## ZONING BOARD OF APPEALS

**To:** Zoning Board of Appeals Members  
**From:** Brenda Belsanti, ZBA Clerk  
**Date:** December 07, 2022  
**Subject:** Materials for **December 21, 2022** Public Hearing

1. **#09-22** Northland 160 Charlemont, LLC, requesting a Comprehensive Permit, pursuant to M.G.L. Chapter 40B, to construct a nine-story mixed-use development with 410 residential units and approximately 10,689 square feet of ground floor commercial space on 6.98 acres of land located at 160 Charlemont Street and 56 Christina Street in the Mixed Use 1 Zoning District. The proposal includes 103 affordable units and 486 parking stalls.

**NORTHLAND CHARLEMONT  
PROPOSED 40B DEVELOPMENT  
ZBA HEARING RESPONSES**

## SHRUB, GRASSES & GROUNDCOVER PLANTING

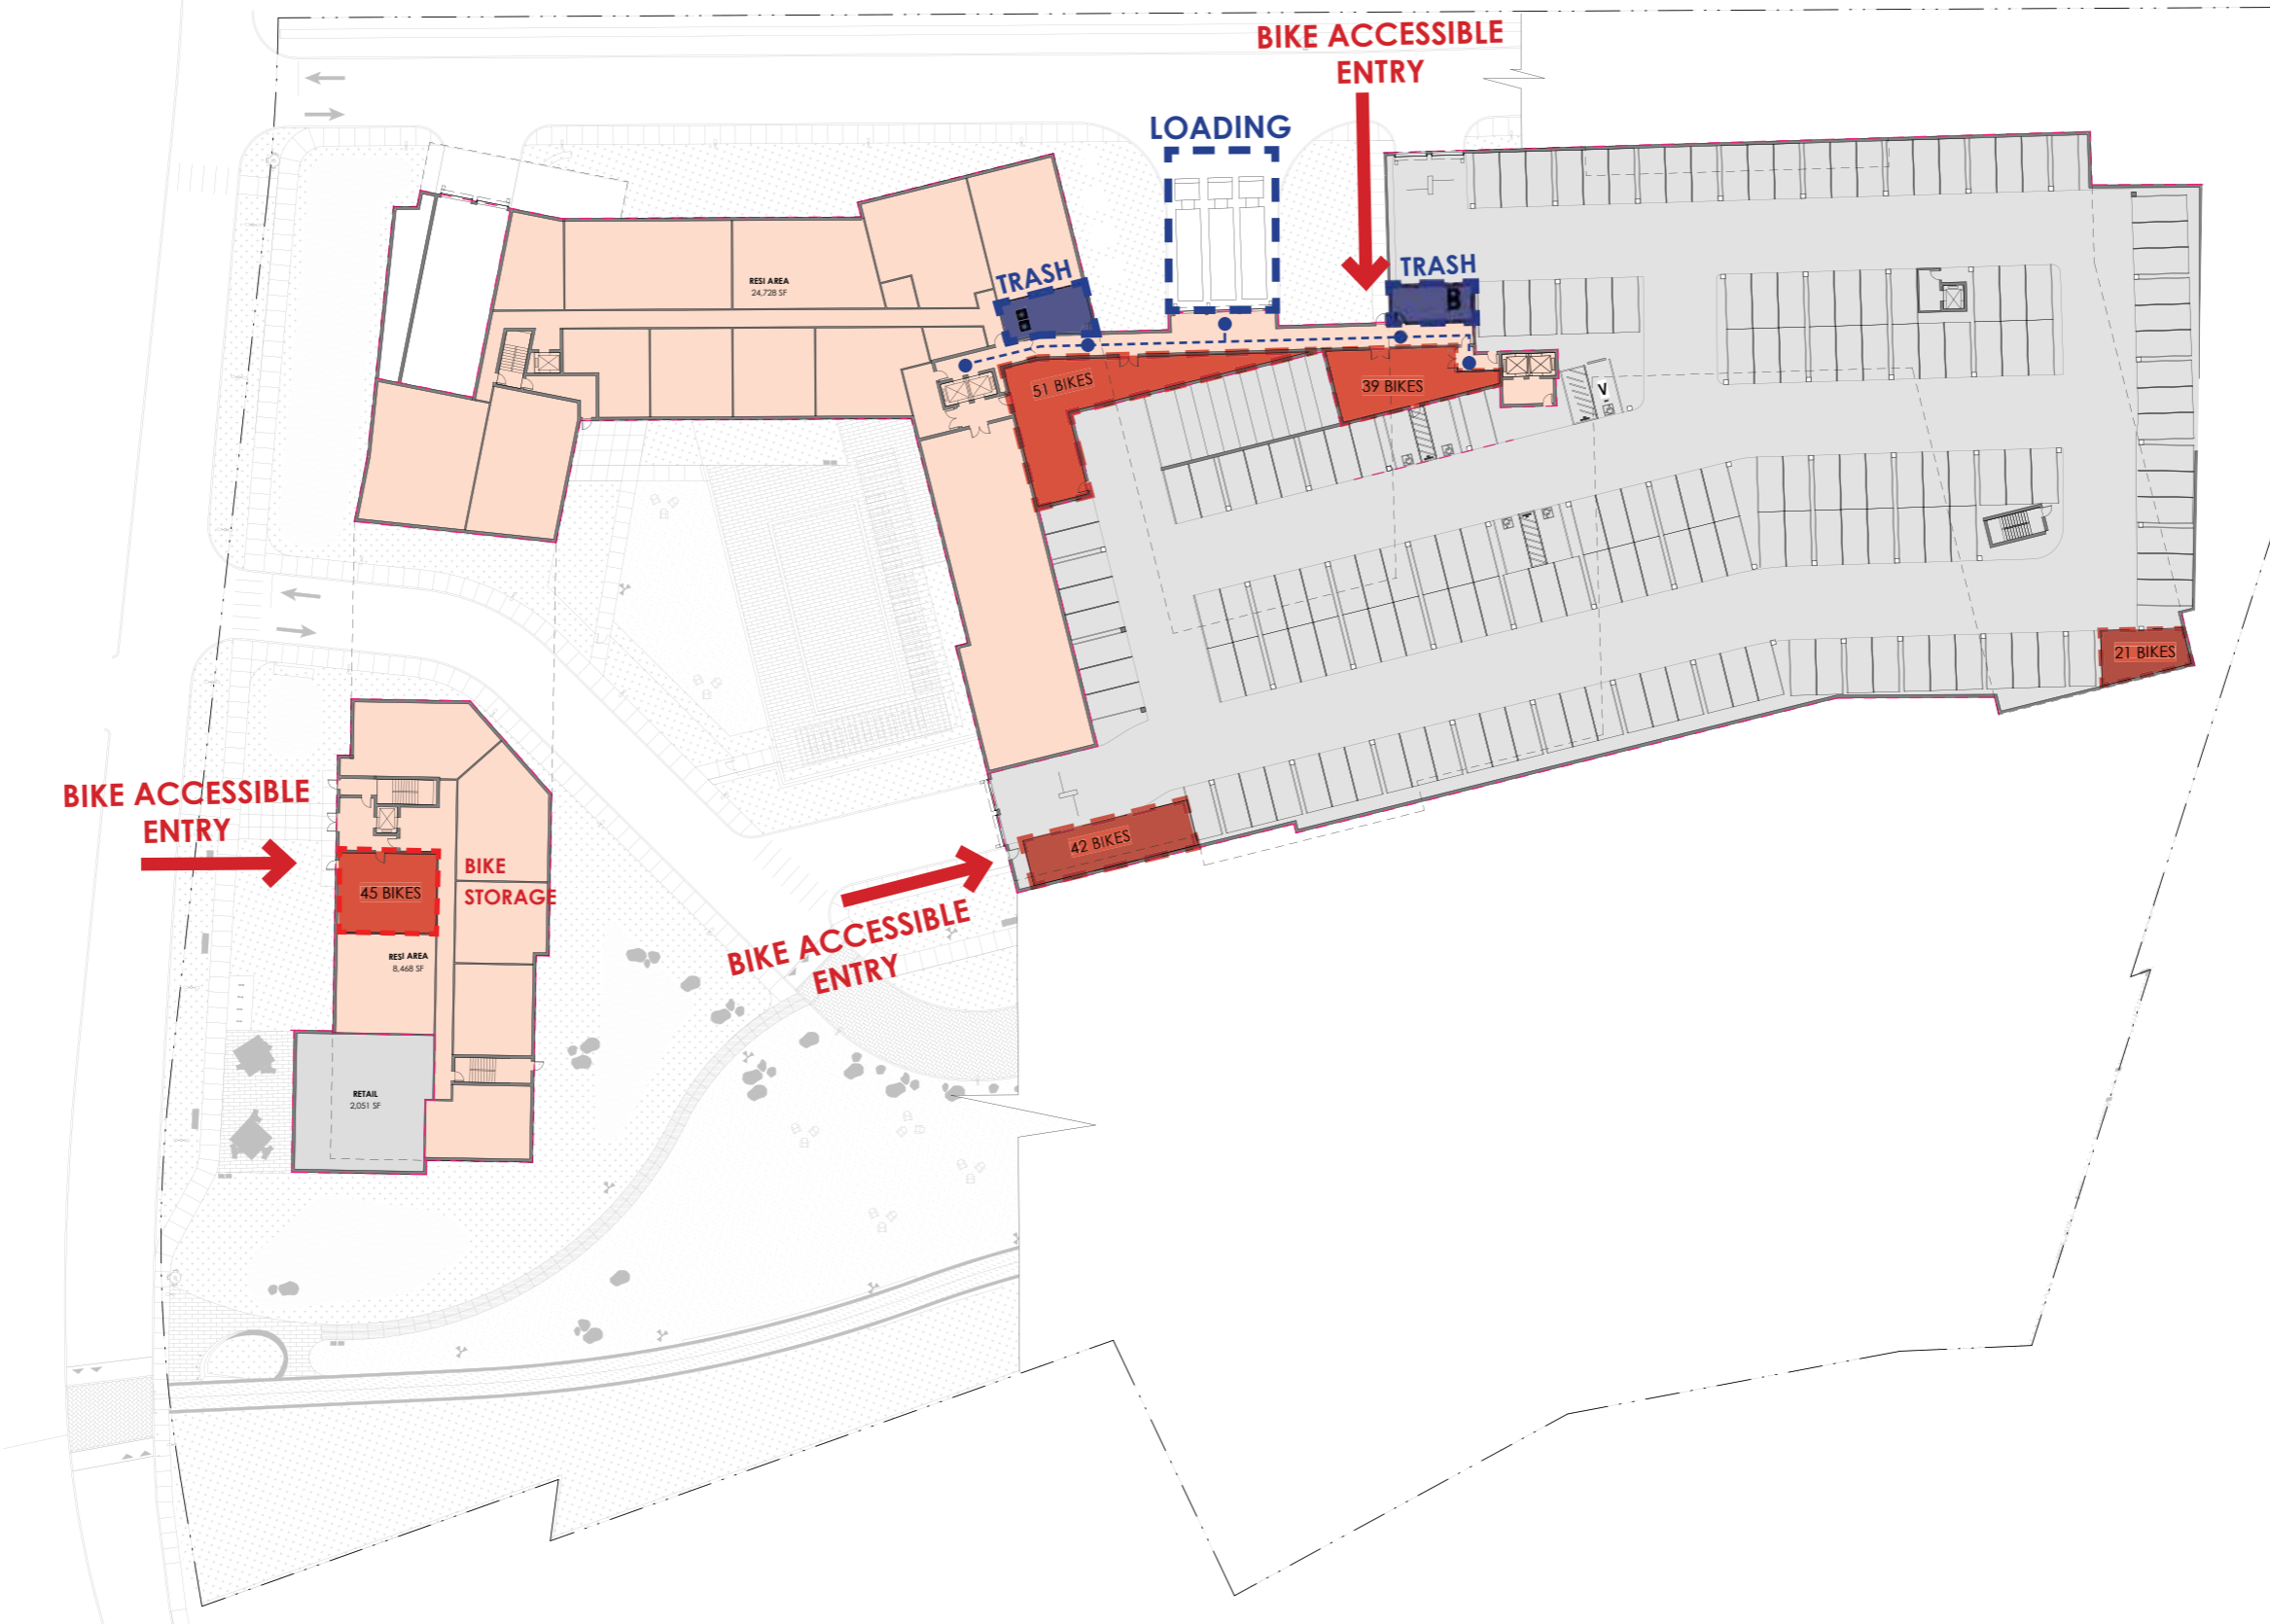
*b. Is this too much lawn? Consider replacing grass with pollinators.*

**R7b.** Please see Stantec package page 4, Planting Typologies.

- The lawn currently comprises 20% of total planted area across the site. Lawn areas are specifically designed to facilitate play and relaxation in an open and flexible way. The remaining planting areas account for 80% of the site and will feature native trees, shrubs, and perennials to provide a natural habitat for pollinators.

## SHADOW STUDIES : DECEMBER 21<sup>ST</sup>

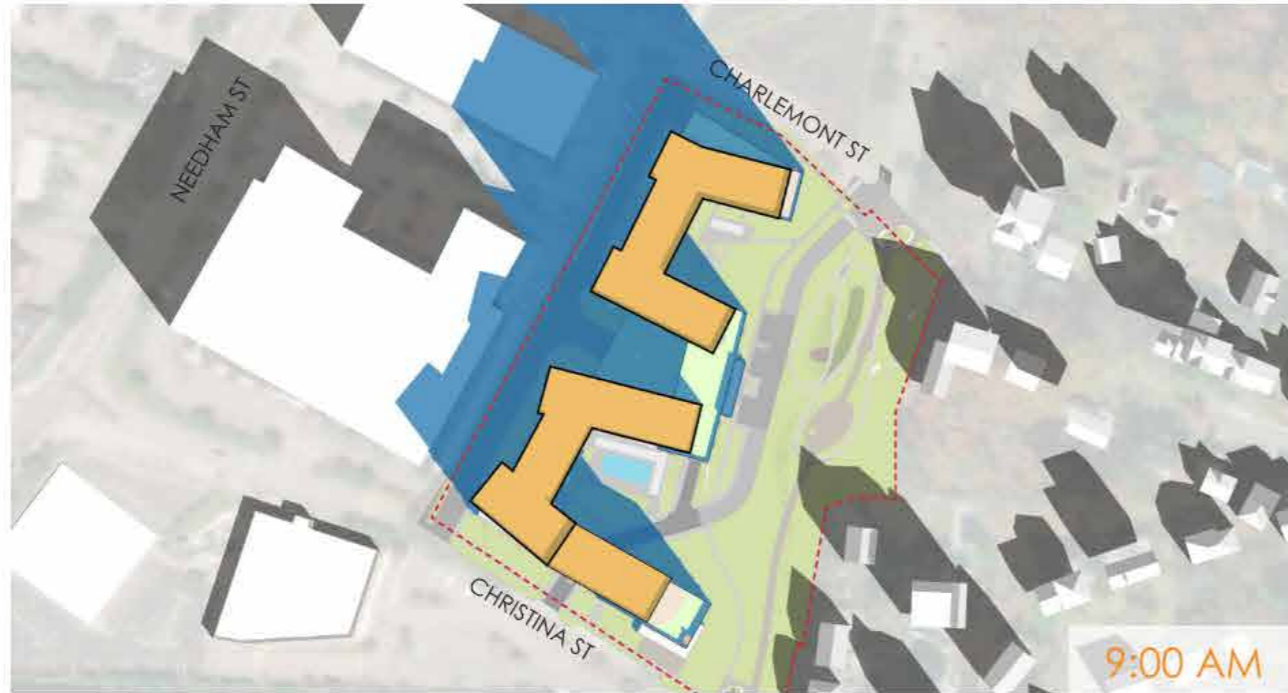
HW noted that the submitted shadow studies indicate that that shadow impacts do not appear to be significant, but recommend the applicant provide additional information as to how the created shadows might affect the open space and residential neighborhood to the east.
